ENGINEERING REPORT

SUBJECT ENGINE PRELUBE/KEEPWARM SYSTEM REQUIREMENTS

REPORT TITLE KEEPWARD L.O. SYSTEM MODIFICATION
NUCLEAR STANDBY UNITS (OP ENGINES)GENERAL

Subject: Detroit Edison Co. P.O. 1E90236
Fairbanks Morse Diesel Gen Sets

FIGURE 1 - L.O. CIRC.
ELECTRICAL SYSTEM
REF: 11867887

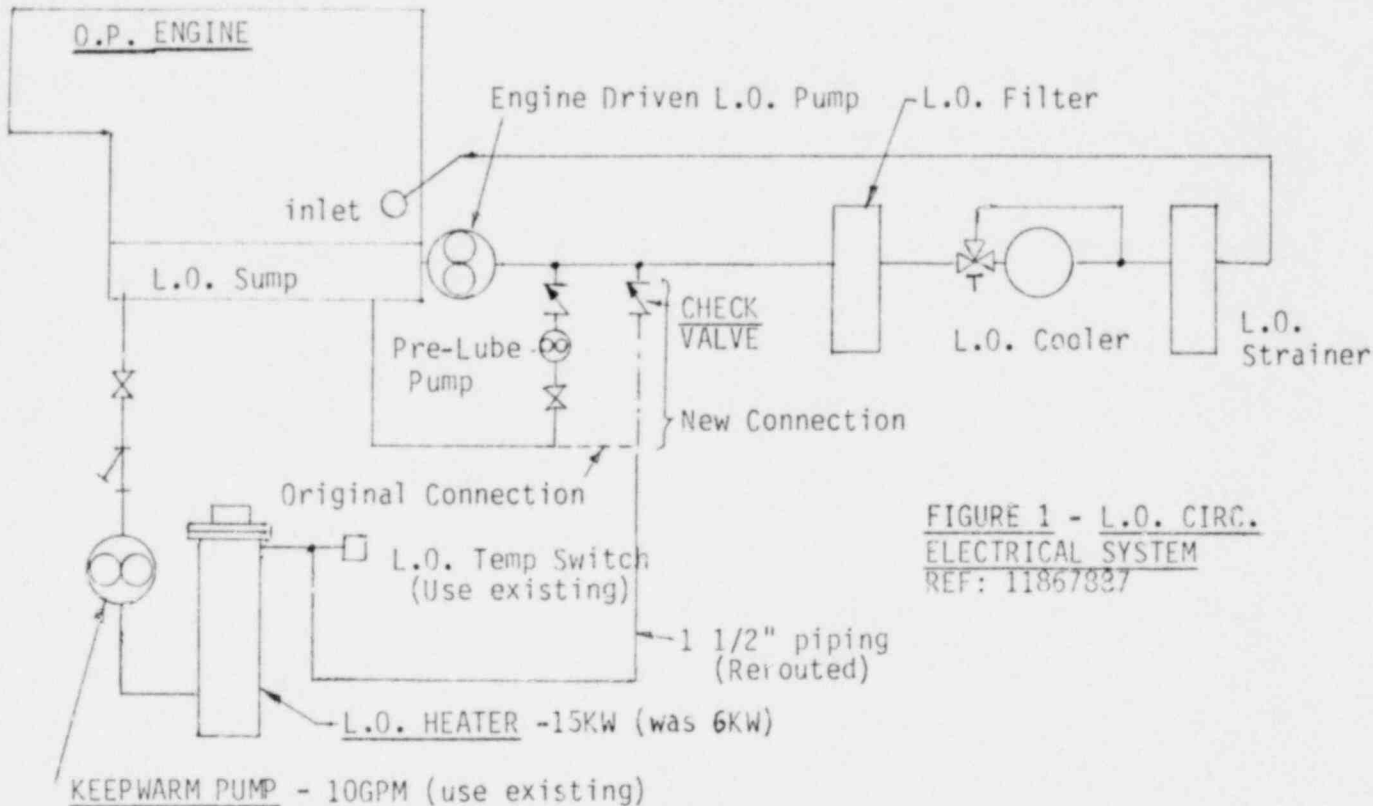
Figure 1 shows the final system arrived at resulting from this development program. In summary, the lube oil circulating system was modified so that oil was delivered to the system at a point near the engine driven pump discharge, thru a check valve. The L.O. circulating heater was increased in capacity from 6 to about 15KW in order to maintain L.O. temperature (viscosity) and to account for the greater losses in the L.O. system because of the increase in the extent of piping thru which the oil would then flow.

Mechanical (Ref: Figure 1)

1. Change the 6KW L.O. heater to 15KW. Information from the most probable vendor indicates that a 15KW heater unit, not exceeding 15 watts per square inch of heater element, can be provided and can be accommodated on the skid in place of the present heater, using the same mounting arrangement. The new unit is about the same size as the present J.W. heater. L.O. inlet would be at the same location.
2. Change the piping from the discharge of the new heater to a point in the piping at the discharge of the engine driven pump (at the same location to which the prelube pump is now piped), including a check valve (same check valve as used with the prelube piping). Include a connection for location of the thermostatic switch (OHT) at the heater outlet. 1 1/2" piping is required.
3. Block off the cross to which the old connection was made (drain to front of L.O. sump).

FIGURE 2
ELECTRICAL SYSTEM
MODIFICATION
REF: 11867708
SHEET 2

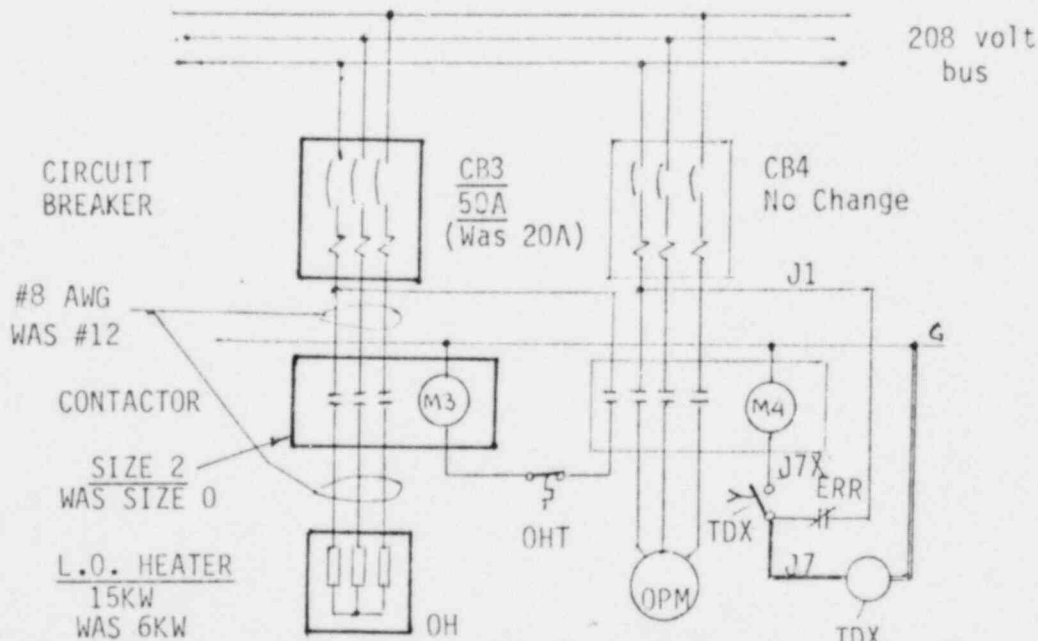
REPORT TITLE KEEPWARD L.O. SYSTEM MODIFICATION
NUCLEAR STANDBY UNITS (OP ENGINES)Electrical (Ref: Figure 2)

1. Relocate conduit to heater connection and thermostatic switch connection as required (raised approx. 12").
2. Replace CB3 (20A) with a 50A unit (Same as CB1). (Our drawings do not indicate source on this item. Customer should identify circuit breaker unit manufacture so that it can be duplicated.)
3. Replace M3 contactor with 11905926 (Cutler Hammer C20DN3A) (Same as M1).
4. Replace wiring (3 wires each) between CB3 and M3 and between M3 and the heater (OH) with #8 AWG (was #12).
5. Add a Time Delay Relay - TDX (FM #11904628 - Agastat 7012AH) in the circuit as shown on the electrical schematic - Figure 2.

(One side of the coil to wire G, other side of coil to wire J7. One side of switch to wire J7 [removing J7 from coil of M4]. New wire J7X between other side of switch [N.O. contacts] to coil of M4 (from which wire J7 was removed.)

6. TDX has a range from 3 to 30 minutes and should be set at 10 minutes.

FIGURE 3 - ENGINE INTERNAL MODIFICATIONS

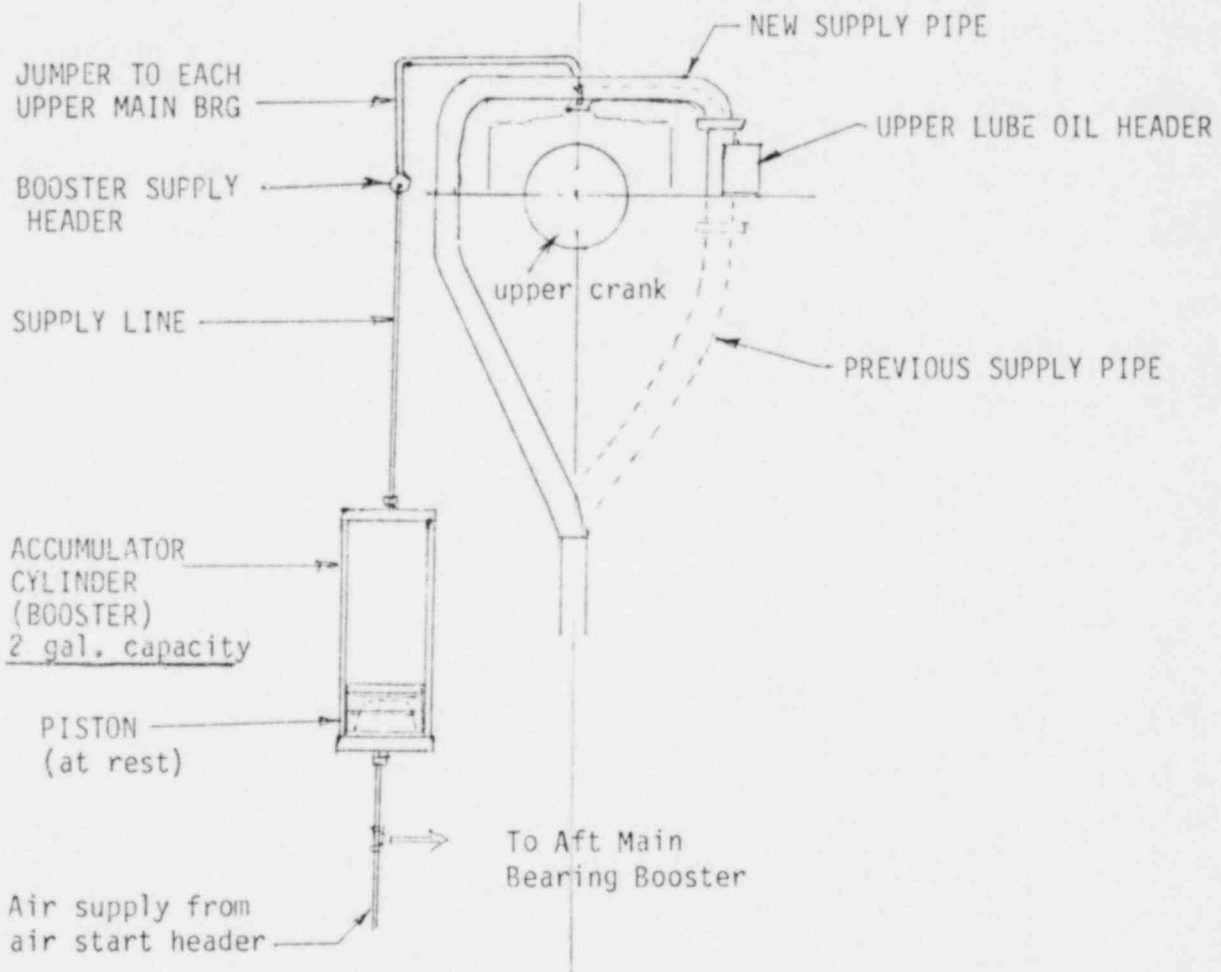
MODIFICATION TO INTERIOR OF ENGINE (Ref: Figure 3)

This modification consists of rerouting the supply to the upper L.O. header such that the header will not readily drain (a loop of tubing up over the crankshaft above the level of the header). See Figure 3.

This modification also consists of adding a lube oil booster/accumulator system to the upper crankline, similar to that used on the aft lower main bearing. This booster system fills with oil during normal engine operation. The next time the engine is started, the lube oil accumulated in the cylinder assembly is forced by starting air pressure acting on the opposite side of a piston, to be fed into the bearings along the upper crankline, thus filling the bearings with oil as the engine begins to be rotated in starting.

No external connections are required with this system as the air supply to the accumulator is tied internally to that of the aft main bearing booster system. The system is self regulating.
